Staff recommends **approval** of Case No. 2025-DEV-001, Delaware Ridge Rezone, at 24132 139th Street.

DELAWARE RIDGE

ZONING EXHIBIT

SELF STORAGE - DELAWARE RIDGE
 LANSING, KS

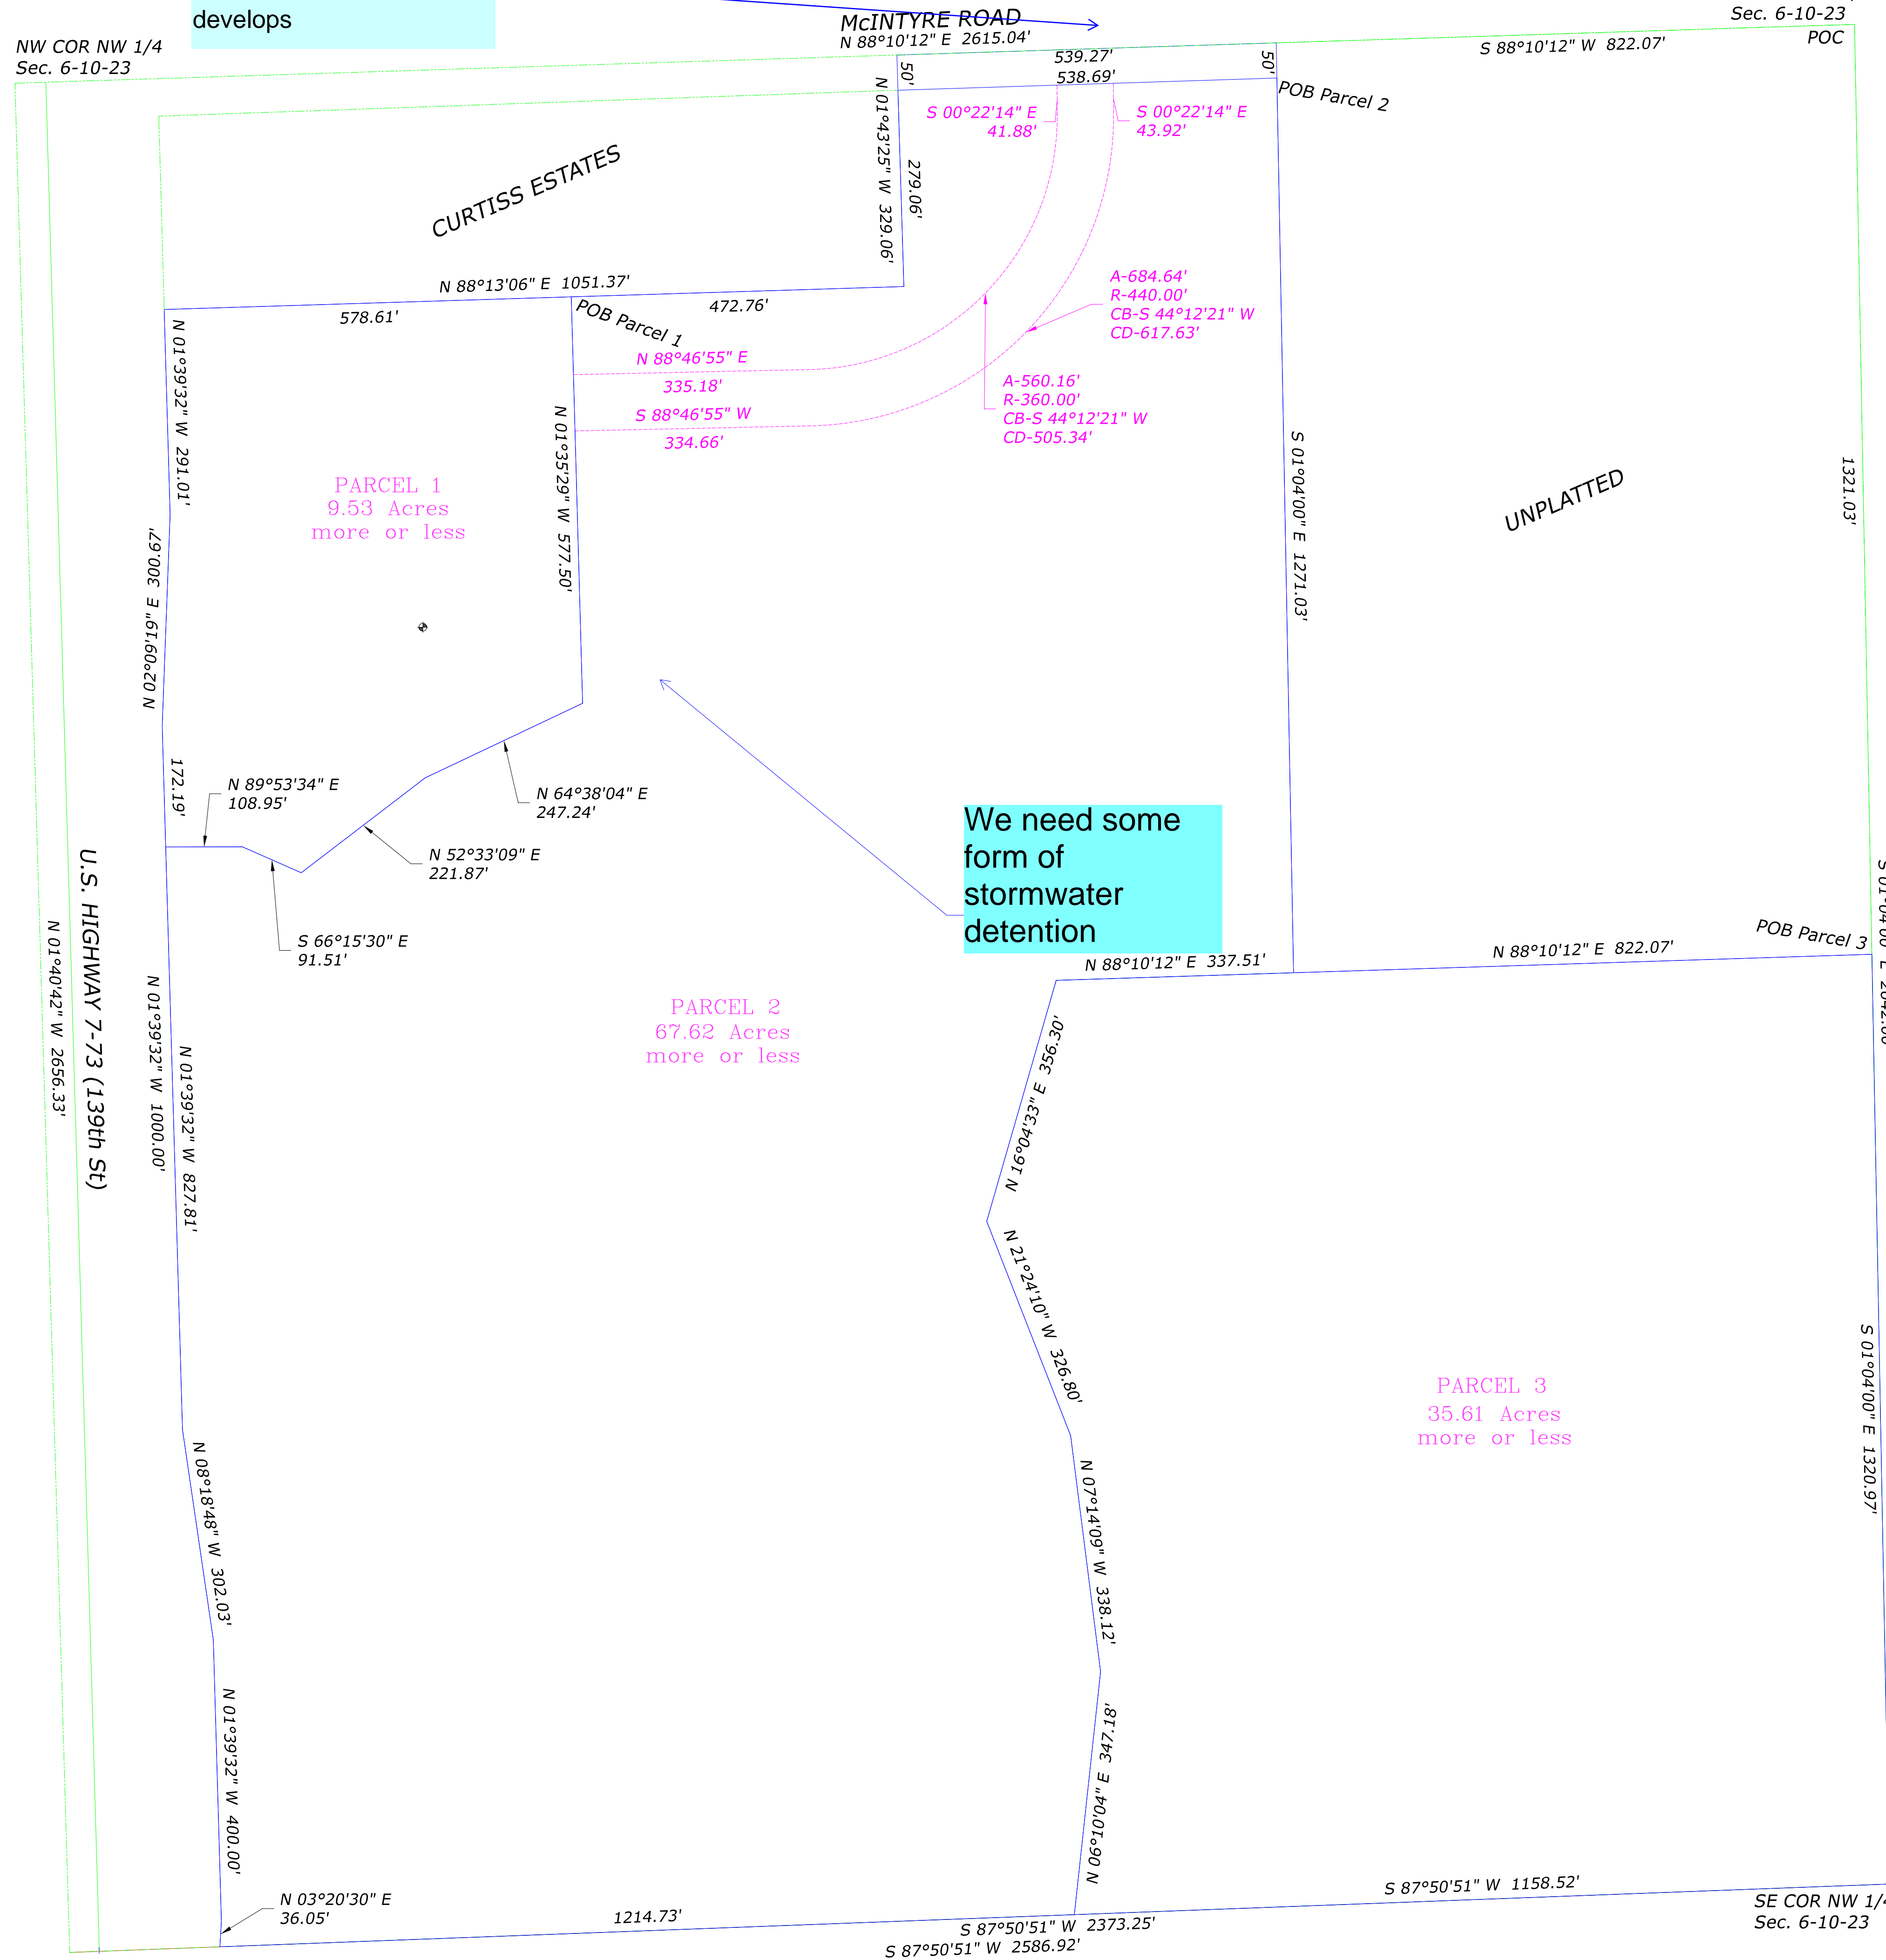
This access configuration is considered "temporary" until the further site develops

We need some form of stormwater detention

ARCHITECTURAL SITE
 PLAN

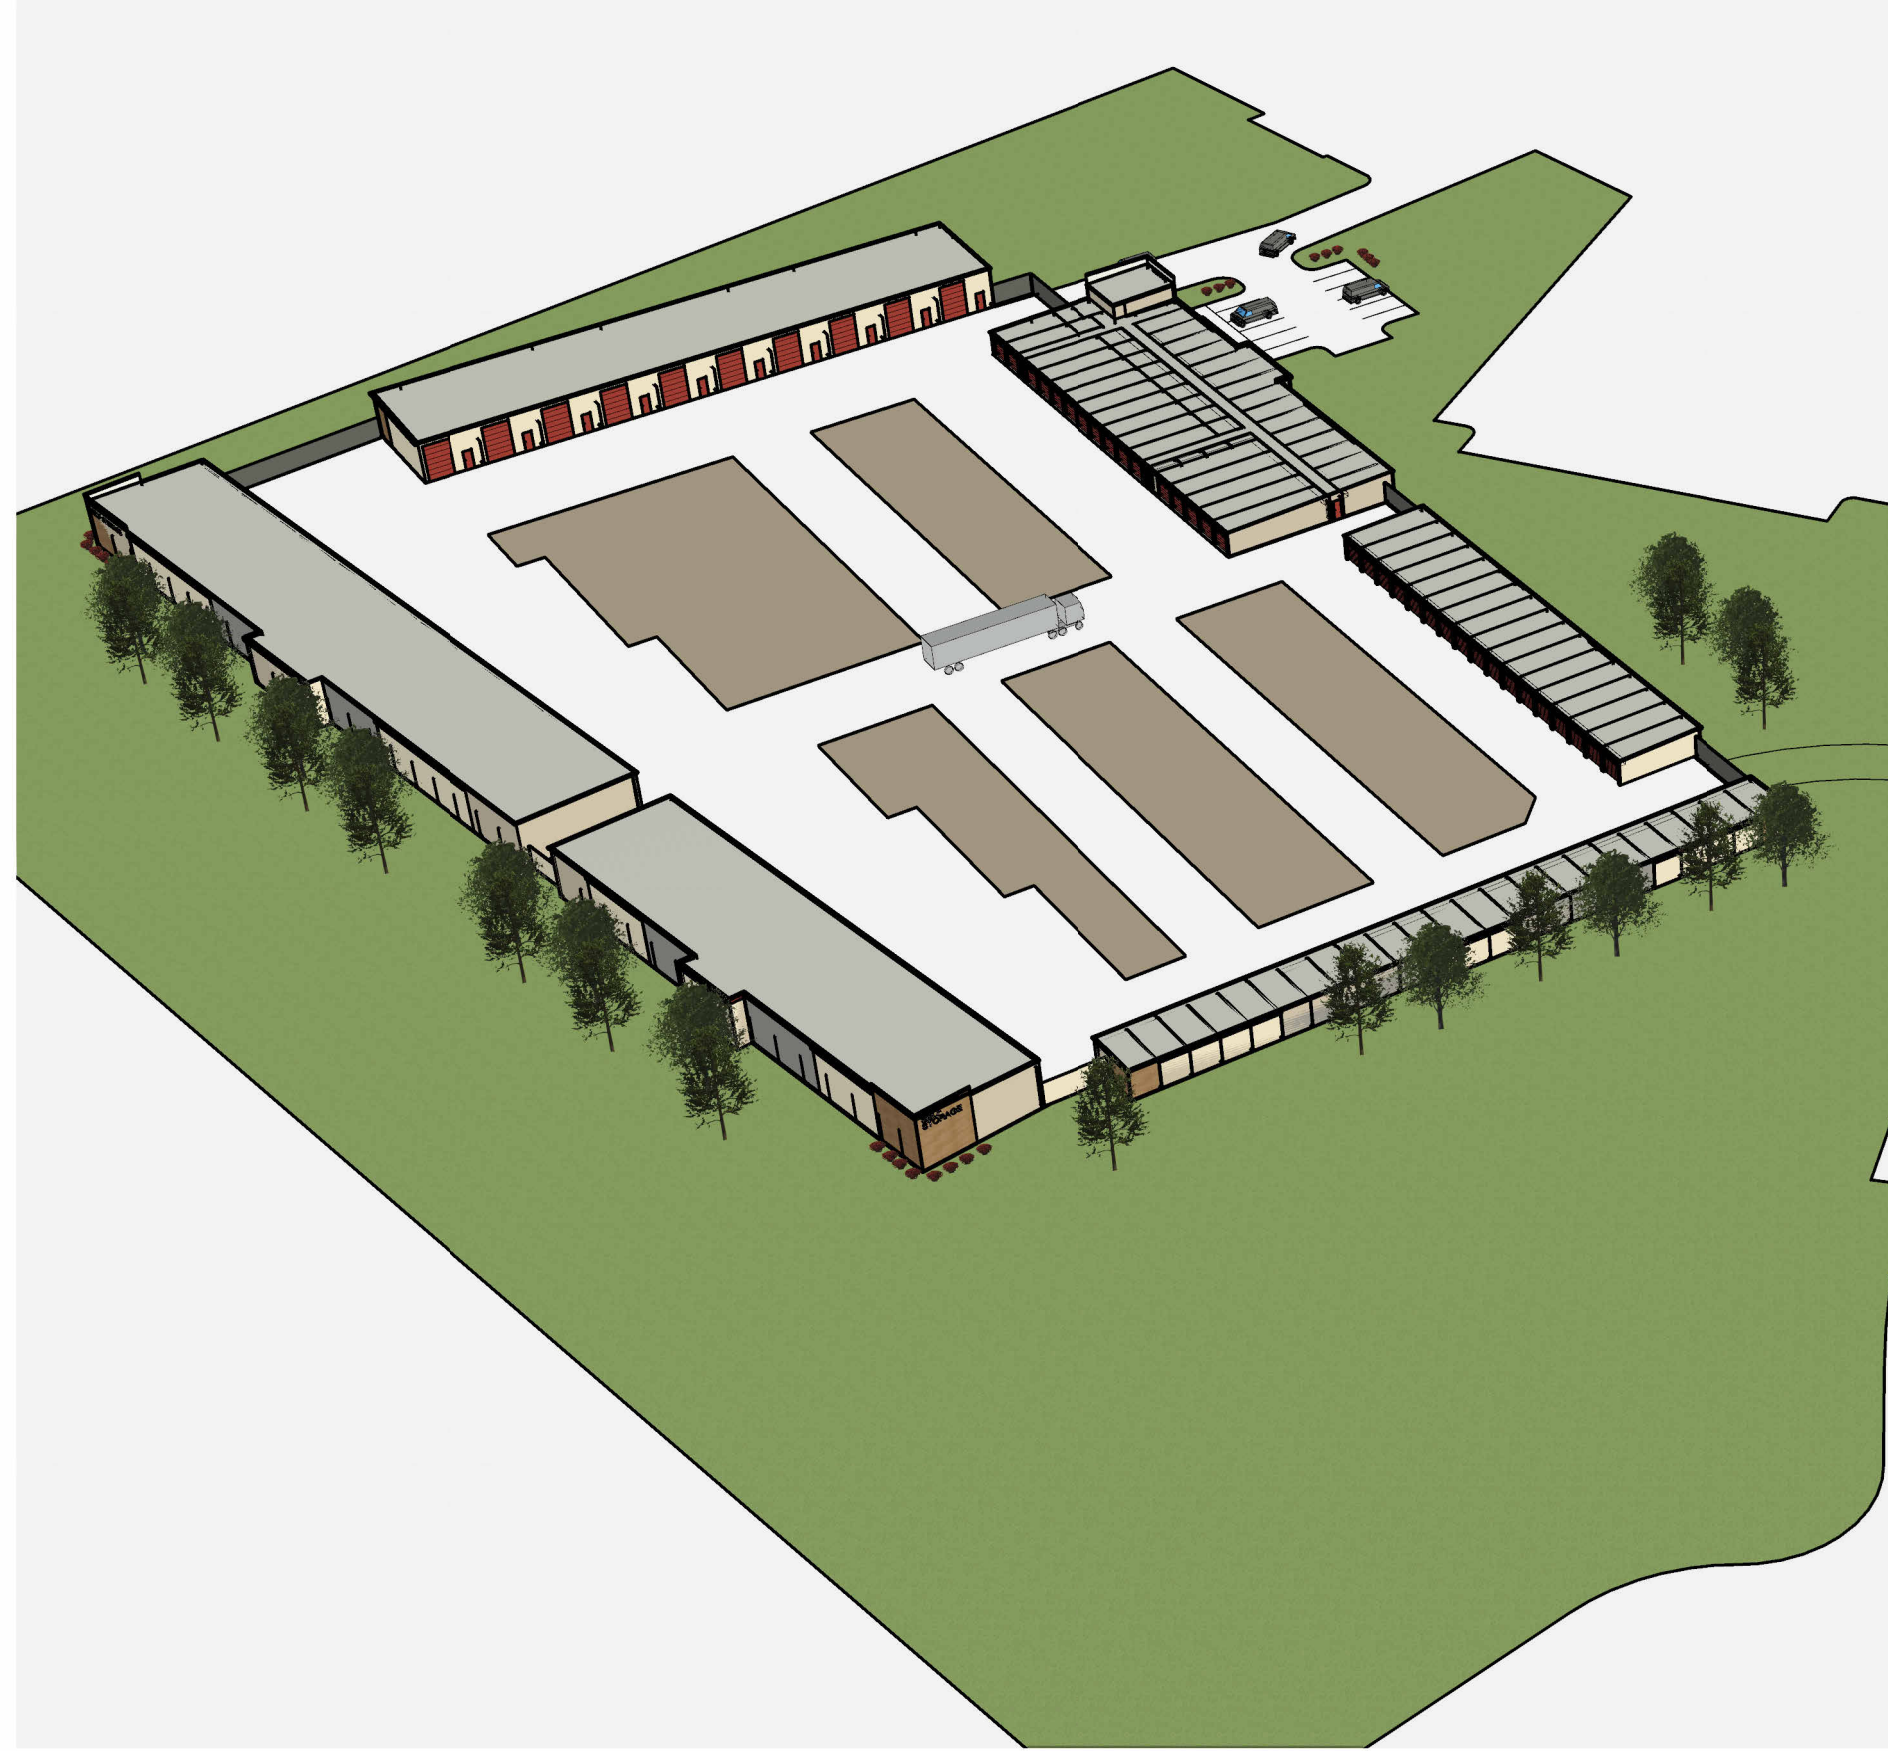
Stormwater Detention?
